**SUNDRY NOTICES AND REPORTS ON WELLS**  
*Do not use this form for proposals to drill or to re-enter an abandoned well. Use Form 3160-3 (APD) for such proposals.*

**DJR Operating, LLC requests permission to plug and abandon the subject well per the attached procedure, current and proposed wellbore diagram.**

### South Blanco 6 #4

Re: Permanent Abandonment  
Well: South Blanco 6 #4

## Proposed P&A Lybrook Gallup Ext.

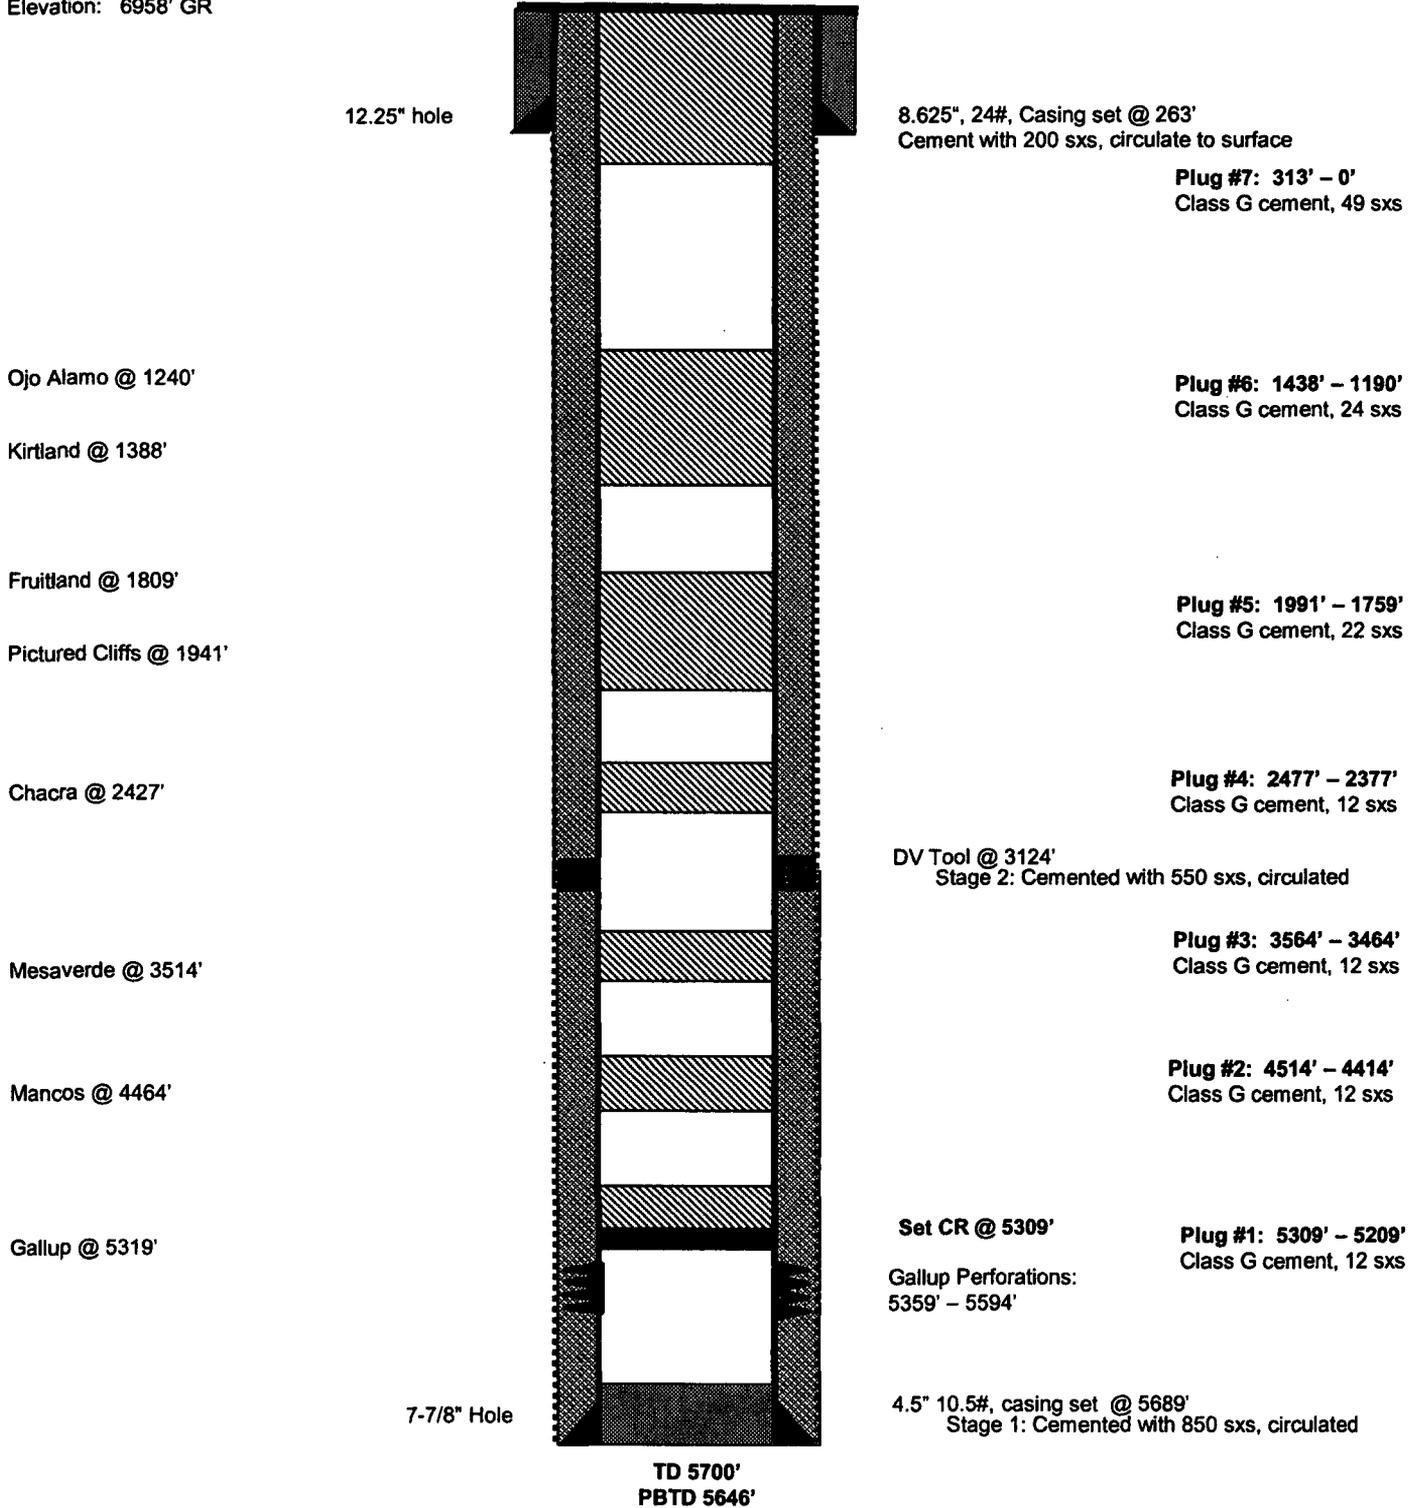
1. Plugging operations authorized are subject to the attached "General Requirements for Permanent Abandonment of Wells on Federal and Indian Lease."
2. Farmington Office is to be notified at least 24 hours before the plugging operations commence (505) 564-7750.
3. The following modifications to your plugging program are to be made:
  - a) Set plug #3 (2798 – 2698) ft. to cover the Mesaverde top. BLM picks top of Mesaverde at 2748 ft.
  - b) Set plug #4 (2360 - 2260) ft. to cover the Chacra top. BLM picks top of Chacra at 2310 ft.
  - c) Set plug #5 (1988 - 1740) ft. to cover the PC and Fruitland tops. BLM picks top of Pictured Cliffs at 1938 ft. BLM picks top of Fruitland at 1790 ft.

You are also required to place cement excesses per 4.2 and 4.4 of the attached General Requirements.
